# SUBDIVISION REPORT - CONCEPT/DEVELOPMENT PLAN

▶ **FILE #:** 2-SC-24-C  
2-C-24-DP

▶ **SUBDIVISION:** SOUTH CREEK DEVELOPMENT  
▶ **APPLICANT/DEVELOPER:** PARAGON DEVELOPMENT, LP  
**OWNER(S):** Paragon Development LP

**SOUTH CREEK SUBDIVISION UNIT 2**  
**204 SWEETWATER LANE**  
**KNOXVILLE, TENNESSEE 37920**  
**CONCEPT PLAN**  
**MPC FILE NUMBERS: 2-SC-24-C / 2-C-24-DP**

JOB NO: 699.001  
 DATE: 12/27/2023  
**C1**  
 CONCEPT PLAN  
 12/27/23

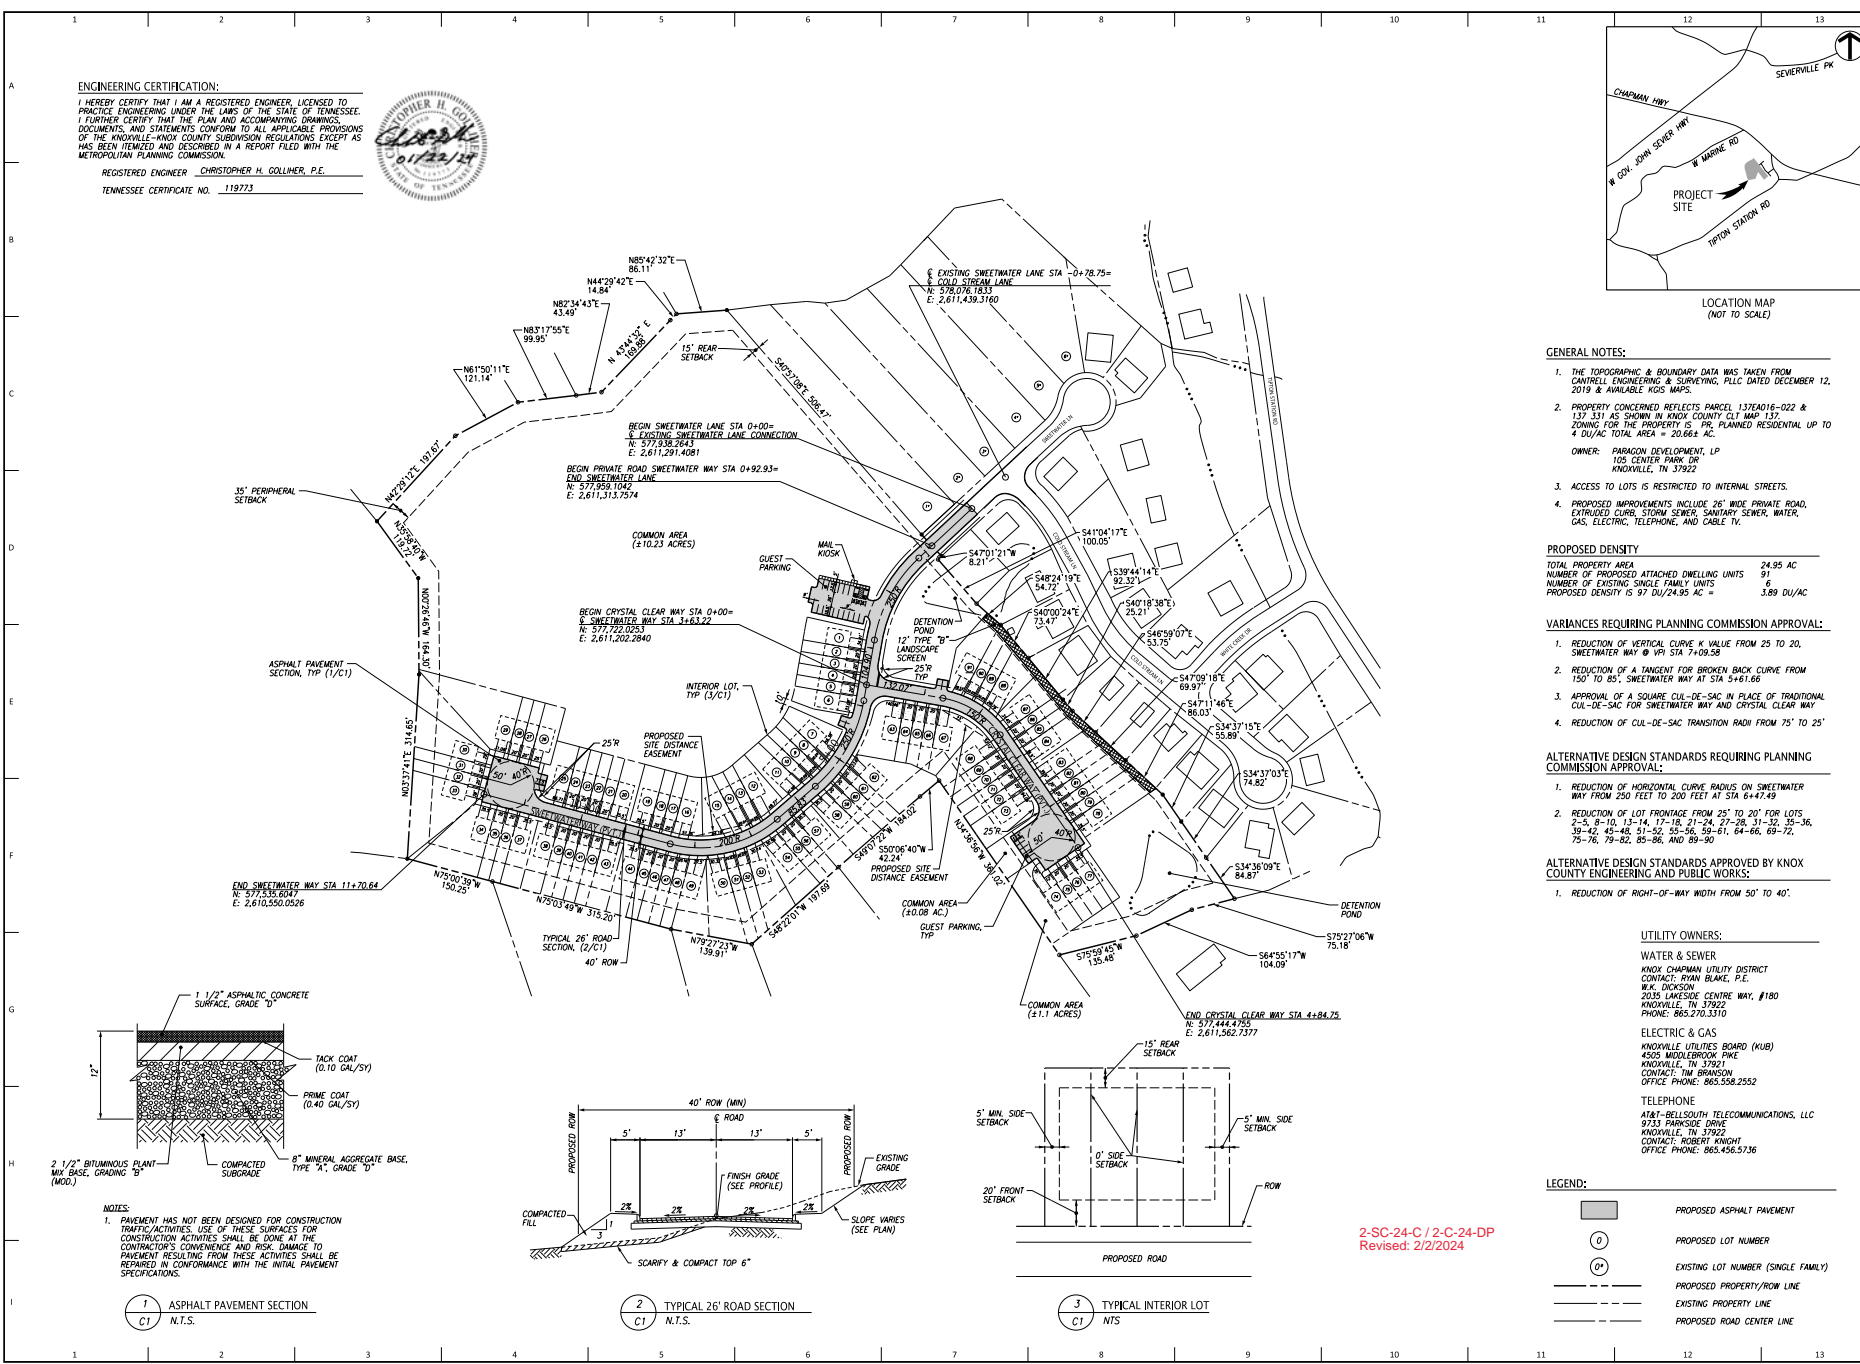
▶ **SUBDIVISION VARIANCES REQUIRED:** **VARIANCES**  
1) Reduce the minimum vertical curve K value from 25 to 20 on Sweetwater Way at VPI STA 7+09.58.  
2) Reduce the minimum broken back curve tangent from 150 ft to 85 ft on Sweetwater Way at STA 5+61.66.  
3) Approval of a square cul-de-sac in place of a traditional cul-de-sac at the end of Sweetwater Way and Crystal Clear Way.  
4) Reduce the minimum cul-de-sac transition radii from 75 ft to 25 ft on Sweetwater Way and Crystal Clear Way.

- Approve the requested variance to reduce the minimum vertical curve K value from 25 to 20 on Sweetwater Way at VPI STA 7+09.58.
- The request to reduce the vertical curve K value is due to the rolling ridges with steep slopes and exposed shallow rock. The reduced K value will allow the road to crest the ridge section in a quicker transition to limit the disturbance of the steep slopes.
  - The unique conditions to be considered are the unique shape and topography of the property and the quantity of hillside protection on the site.
  - The purpose of the variation is not based exclusively upon a desire for financial gain but is a result of the property's physical attributes.
  - To our knowledge, the variance will not be a detriment to public safety, health, or welfare, or be injurious to other properties and improvements in the neighborhood.

Approve the requested variance to reduce the minimum broken back curve tangent from 150 ft to 85 ft on Sweetwater Way at STA 5+61.66.

Approve the requested variance to allow a square cul-de-sac in place of a traditional cul-de-sac at the end of Sweetwater Way and Crystal Clear Way.

Approve the requested variance to reduce the cul-de-sac transition radii from 75 ft to 25 ft on Sweetwater Way and Crystal Clear Way.

4. Providing a 200 ft sight distance easement through the 200 ft horizontal radius in Sweetwater Way. The driveways must have a depth of 20 ft outside of the sight distance easement.

- The request to reduce the broken back curve tangent is due to the rolling ridges with steep slopes and exposed shallow rock. The reduction of the tangent length is needed to keep the road aligned closely with the southern property line to prevent the road from being pushed drastically into the steep terrain.
- The unique conditions to be considered are the unique shape and topography of the property and the quantity of hillside protection on the site.
- The purpose of the variation is not based exclusively upon a desire for financial gain but is a result of the property's physical attributes.
- To our knowledge, the variance will not be a detriment to public safety, health, or welfare, or be injurious to other properties and improvements in the neighborhood.

- The request for square cul-de-sacs is due to the geometric and topographic constraints and the need to cluster dwelling units to limit disturbance. The square design will allow all units and driveways to face perpendicular to the right-of-way, eliminating curved driveways and complicated property lines.
- The unique conditions to be considered are the unique shape and topography of the property and the quantity of hillside protection on the site.
- The purpose of the variation is not based exclusively upon a desire for financial gain but is a result of the property's physical attributes.
- To our knowledge, the variance will not be a detriment to public safety, health, or welfare, or be injurious to other properties and improvements in the neighborhood because the turning area within the square cul-de-sac is the same as a traditional cul-de-sac.

- The request to reduce the cul-de-sac transition radii is due to a 75 ft radius not physically fitting within a square geometry of the cul-de-sac without increasing the overall footprint of the turnaround.
- The unique conditions to be considered are the unique shape and topography of the property and the quantity of hillside protection on the site.
- The purpose of the variation is not based exclusively upon a desire for financial gain but is a result of the property's physical attributes.
- To our knowledge, the variance will not be a detriment to public safety, health, or welfare, or be injurious to other properties and improvements in the neighborhood.

**Approve the Concept Plan subject to 7 conditions.**

**C3**  
 CONCEPT PLAN  
 12/27/23

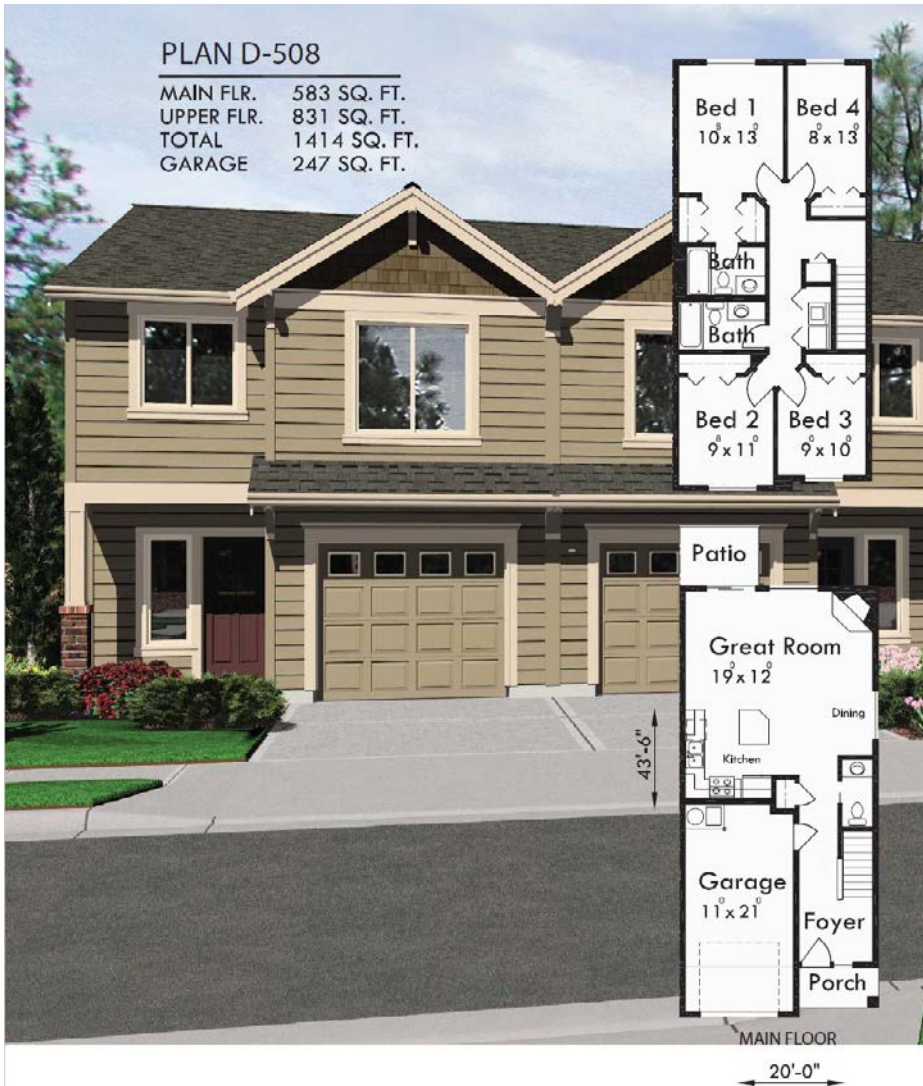
Reduction of Vertical Curve K Value from 25 to 20, Sweetwater Way @ VPI 7+09.58

Reduction of tangent for broken back curve from 150' to 85', Sweetwater Way at Sta 5+61.66

Engineering Comments: Approve based on justification provided by the applicant.

Engineering Comments: Approved based on justification provided by applicant.
